Mack Electromobility Chassis Electrical Center Decal Update

Service Category Service Department

Section Function Group 372

Model Years	Models
2021-2026	LRBe

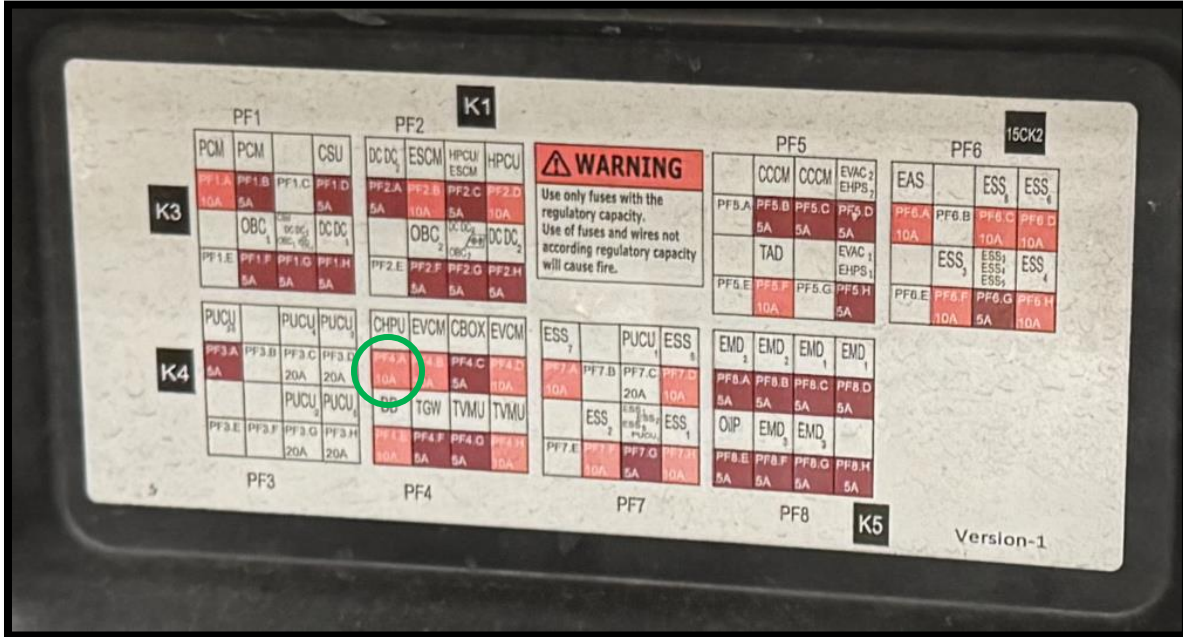
- Inspect and replace (if necessary) the 10A fuse with the new 15A fuse located in the CabHPU PF4.A location circled in green.

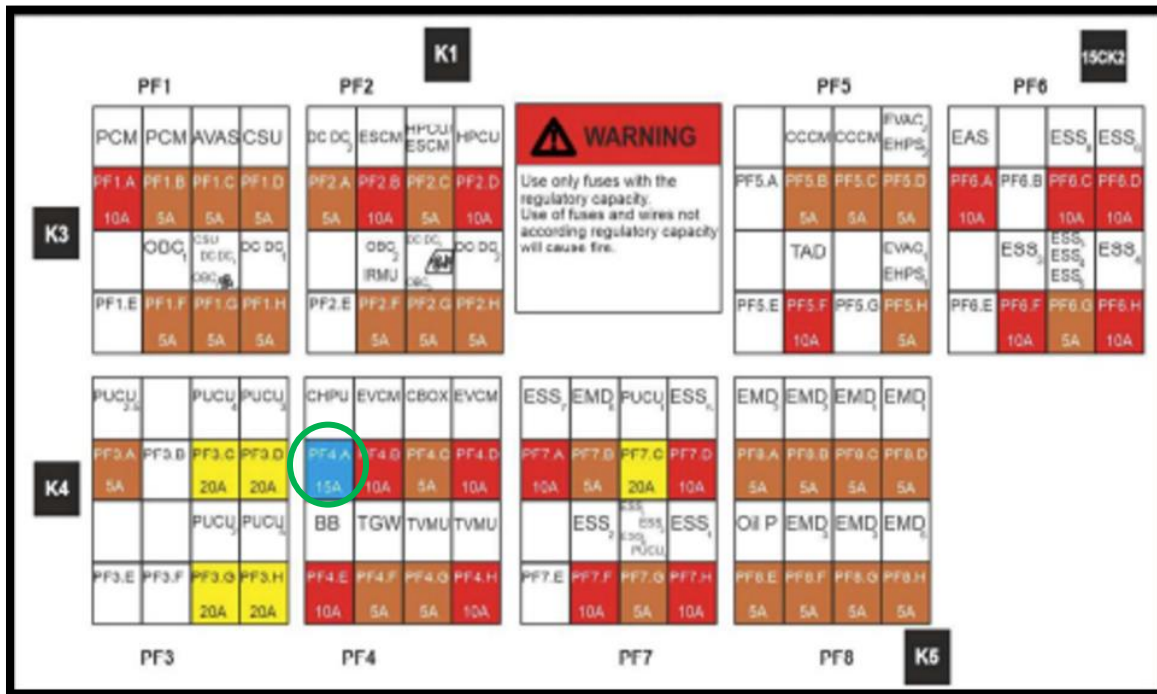
- Install the new label that has the updated fuse information over the old label. Ensure the clean the old label with isopropyl alcohol for better adhesion.
